Well Name: MUSKIE 23-11 FED COM	Well Location: T26S / R34E / SEC 23 / SENE /	County or Parish/State:
Well Number: 35H	Type of Well: OIL WELL	Allottee or Tribe Name:
Lease Number: NMNM100568	Unit or CA Name:	Unit or CA Number:
US Well Number: 3002550067	Well Status: Approved Application for Permit to Drill	Operator: DEVON ENERGY PRODUCTION COMPANY LP

Type of Submission: Notice of Intent Type of Action: Variance

Procedure Description: Devon Energy Production Company, L.P. respectfully requests a break test variance on the subject well. Please see the attached documents.

PECOS DISTRICT DRILLING CONDITIONS OF APPROVAL

Section 2 - Blowout Preventer Testing Procedure

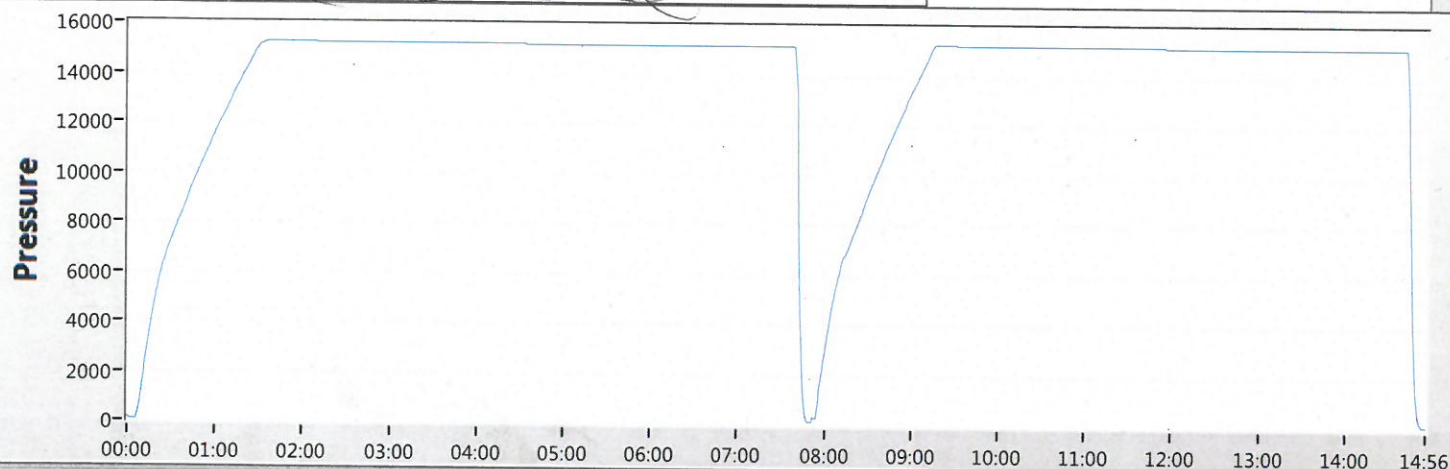
Devon Energy requests to only test BOP connection breaks after drilling out of surface casing and while skidding between wells which conforms to API Standard 53 and industry standards. This test will include the Top Pipe Rams, HCR, Kill Line Check Valve, QDC (quick disconnect to wellhead) and Shell of the 10M BOPE to 5M for 10 minutes. If a break to the flex hose that runs to the choke manifold is required due to repositioning from a skid, the HCR will remain open during the shell test to include that additional break. The variance only pertains to intermediate hole-sections and no deeper than the Bone Springs Formation where 5M BOP tests are required. The initial BOP test will follow OOGO2.III.A.2.i, and subsequent tests following a skid will only test connections that are broken. The annular preventer will be tested to 100% working pressure. This variance will meet or exceed OOGO2.III.A.2.i per the following: Devon Energy will perform a full BOP test per OOGO2.III.A.2.i before drilling out of the intermediate casing string(s) and starting the production hole, before starting any hole section that requires a 10M test, before the expiration of the allotted 14-days for 5M intermediate batch drilling or when the drilling rig is fully mobilized to a new well pad, whichever is sooner. We will utilize a 200' TVD tolerance between intermediate shoes as the cutoff for a full BOP test. The BLM will be contacted 4hrs prior to a BOPE test. The BLM will be notified if and when a well control event is encountered. Break test will be a 14 day interval and not a 30 day full BOPE test interval. If in the event break testing is not utilized, then a full BOPE test would be conducted.

1. Well Control Response:
 1. Primary barrier remains fluid
 2. In the event of an influx due to being underbalanced and after a realized gain or flow, the order of closing BOPE is as follows:
 - a) Annular first
 - b) If annular were to not hold, Upper pipe rams second (which were tested on the skid BOP test)
 - c) If the Upper Pipe Rams were to not hold, Lower Pipe Rams would be third

All Previous COAs Still Apply. Variance request procedure is approved as written, please see below general conditions for variance.

- BOPE Break Testing is ONLY permitted for 5M BOPE or less.
- BOPE Break Testing is NOT permitted to drilling the production hole section.
- While in transfer between wells, the BOPE shall be secured by the hydraulic carrier or cradle.

- Any well control event while drilling require notification to the BLM Petroleum Engineer **(575-706-2779)** prior to the commencement of any BOPE Break Testing operations.

- A full BOPE test is required prior to drilling the first deep intermediate hole section. If any subsequent hole interval is deeper than the first, a full BOPE test will be required (200' TVD tolerance between intermediate shoes is allowable).
